**Final Drainage Report
Rocky Top Resources
Tract 7 Valley Garden Subdivision
1755 East Las Vegas
El Paso County, Colorado**

PCD File No. PPR 1913

Kiowa Project No. 17066
March 26, 2019
August 26, 2019

Detention Basin Outlet Structure Design

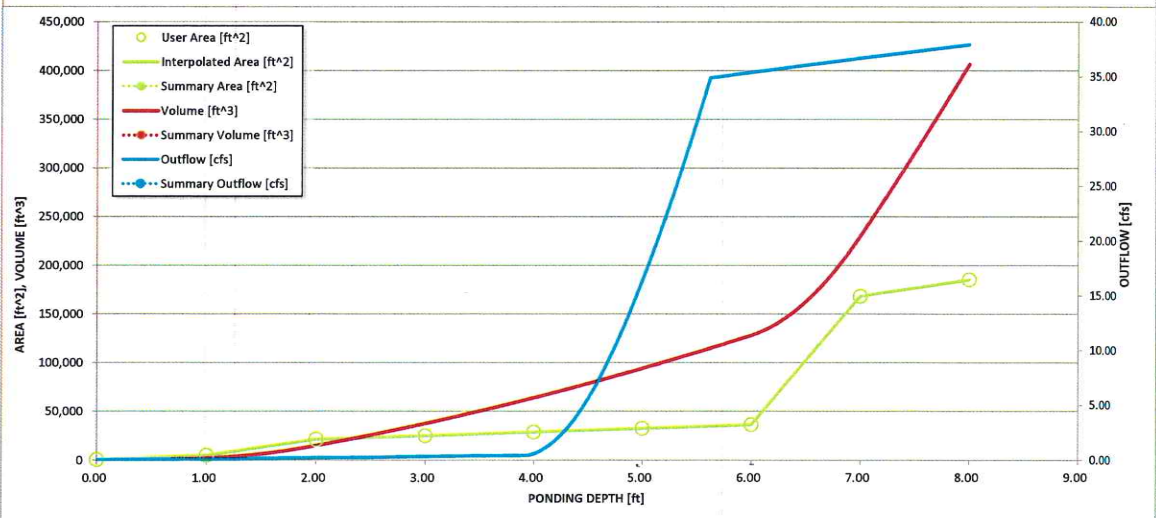
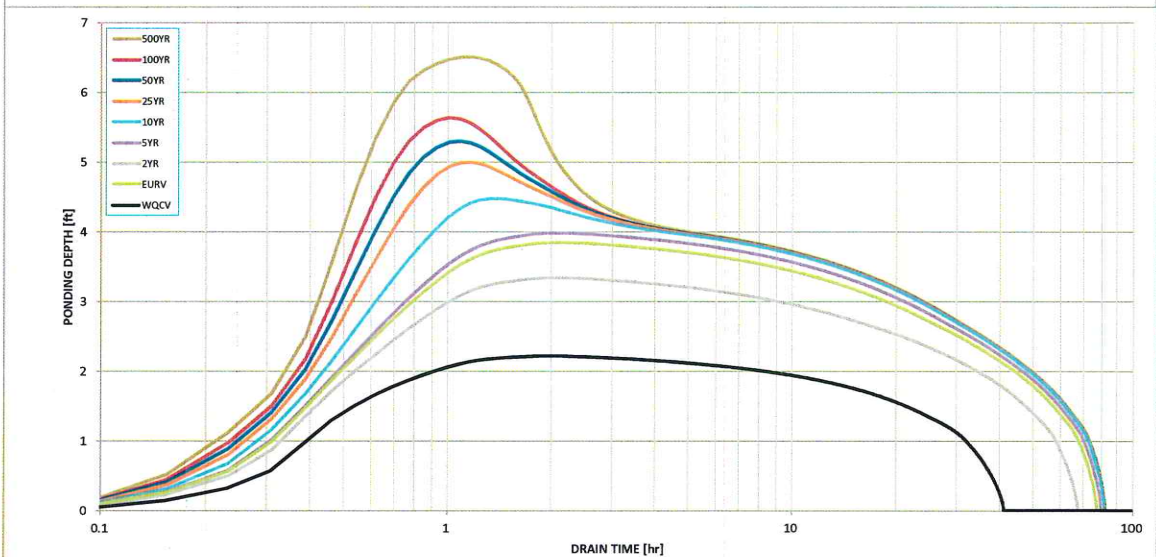
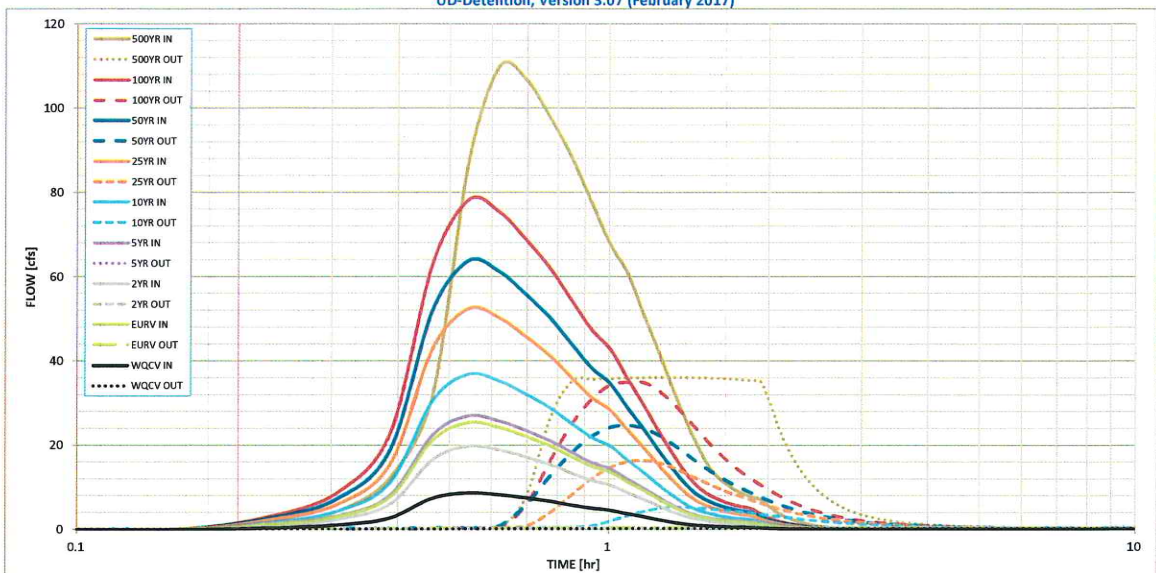
56 ft. from basin bottom? please revise.

ROCKY TOP RESOURCES
PROPOSED DRAINAGE PLAN
TRACT 7 VALLEY GARDEN SUBDIVISION
1755 EAST LAS VEGAS STREET
COLORADO SPRINGS, COLORADO

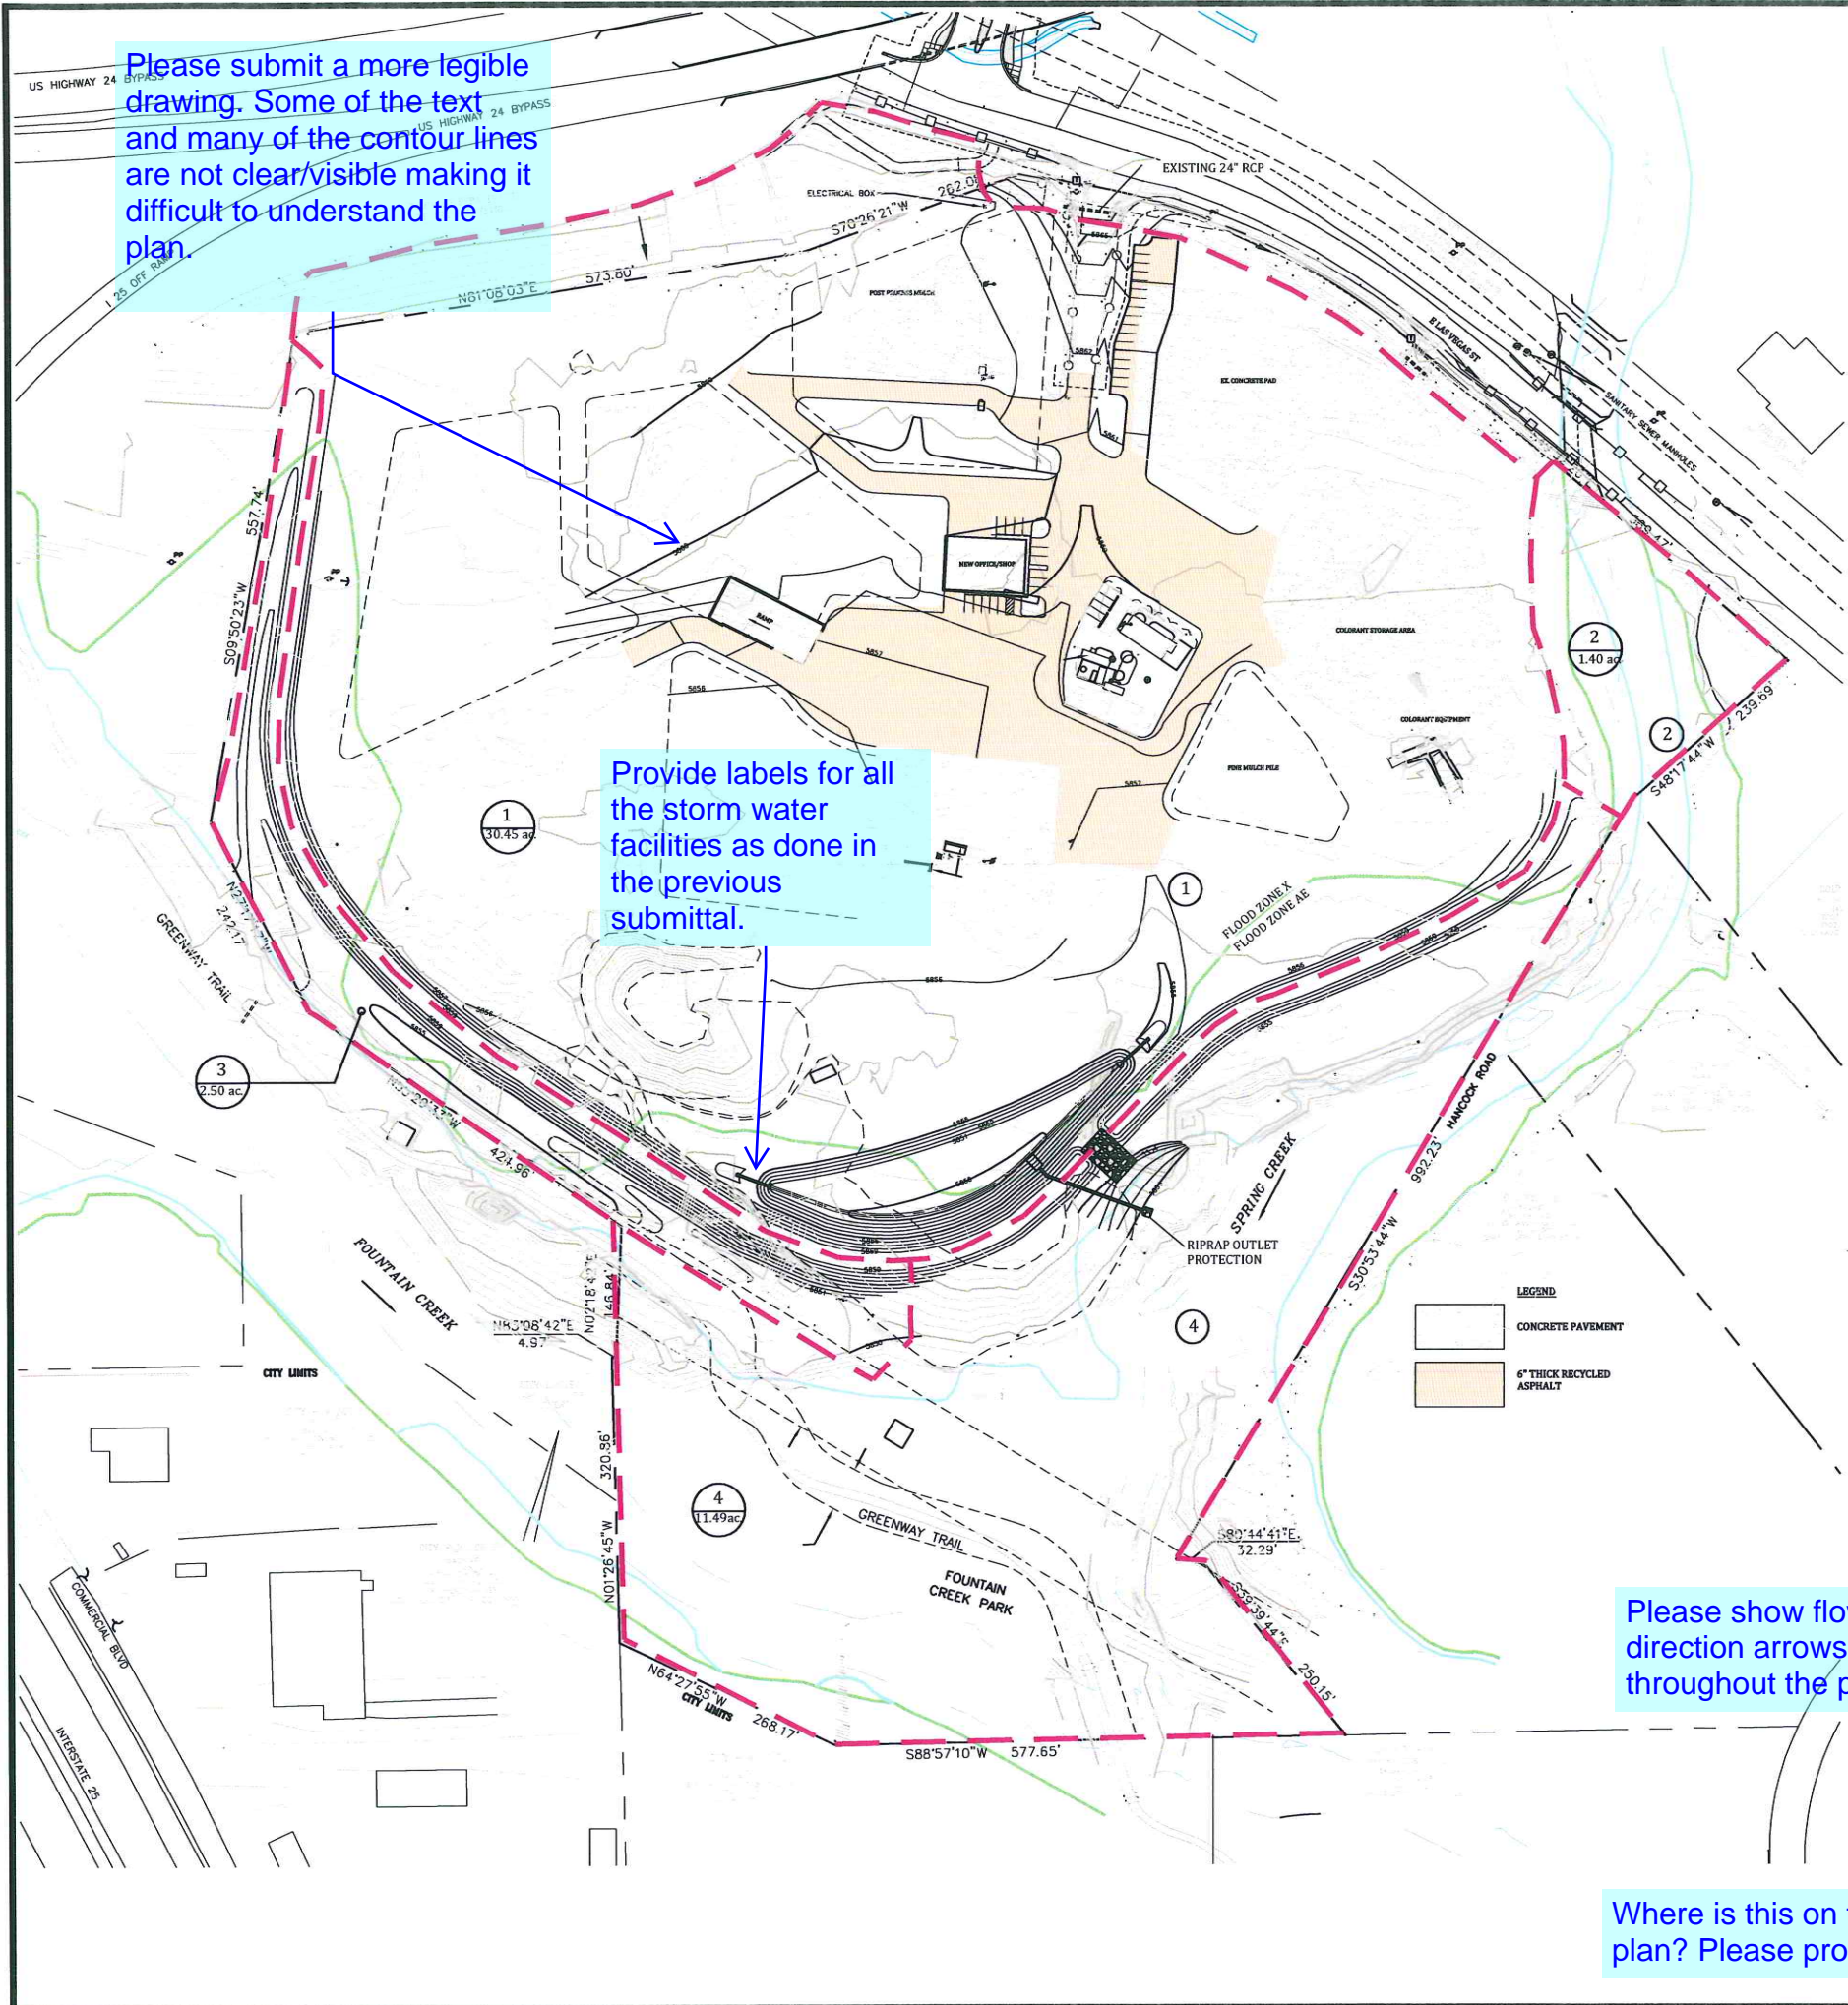
Please revise the discharges of each of the proposed sub-basins. What is written in the narrative does not match the table on the proposed drainage plan or the submitted calculations.

No curb inlets where shown on the drainage plan.
Please revise the text or show them on the plan

Please submit a more legible drawing. Some of the text and many of the contour lines are not clear/visible making it difficult to understand the plan.

Where is this on the plan? Please provide.

Please show flow direction arrows throughout the plan.

Provide labels for all the storm water facilities as done in the previous submittal.

ROCKY TOP RESOURCES
EXISTING DRAINAGE PLAN
TRACT 7 GARDEN VALLEY SUBDIVISION
1755 EAST LAS VEGAS STREET
COLORADO SPRINGS, COLORADO

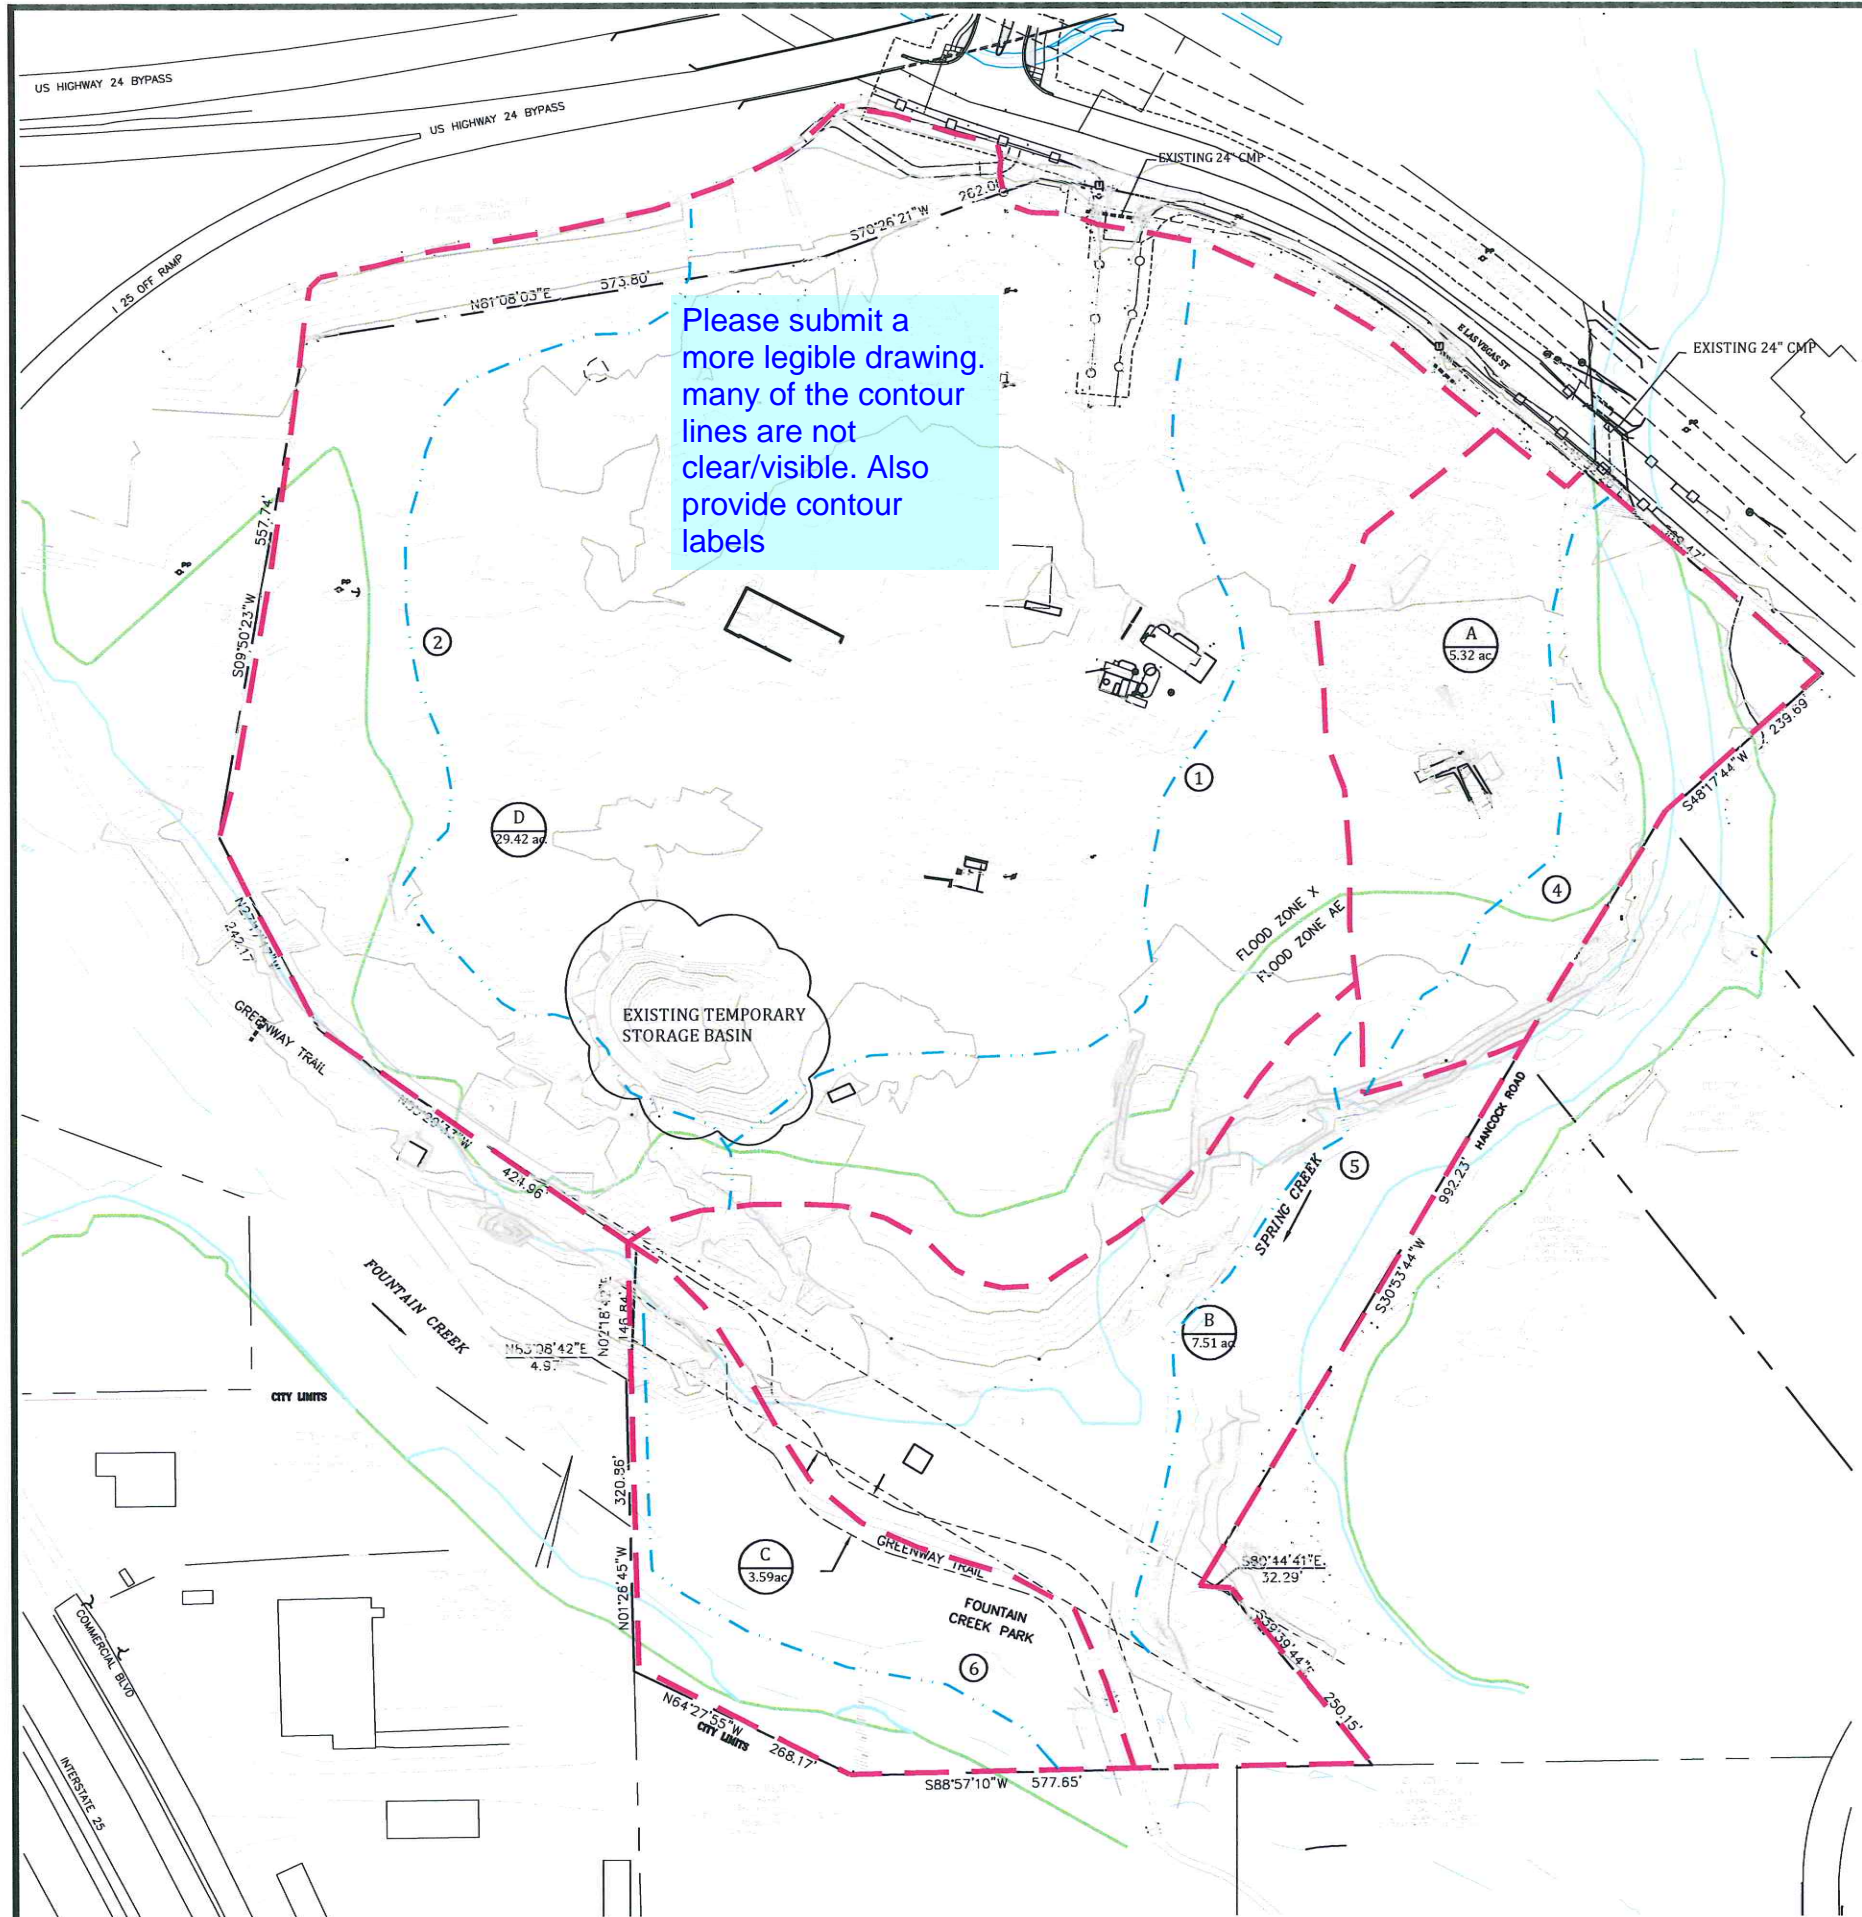
Please provide flow
direction arrows on
the plan

based on the flow path shown on the submitted existing drainage plan, the discharge from sub-basin A does not reach the temporary storage basin. Please revise accordingly.

Please provide flow direction arrows on the plan

Please submit a more legible drawing. many of the contour lines are not clear/visible. Also provide contour labels
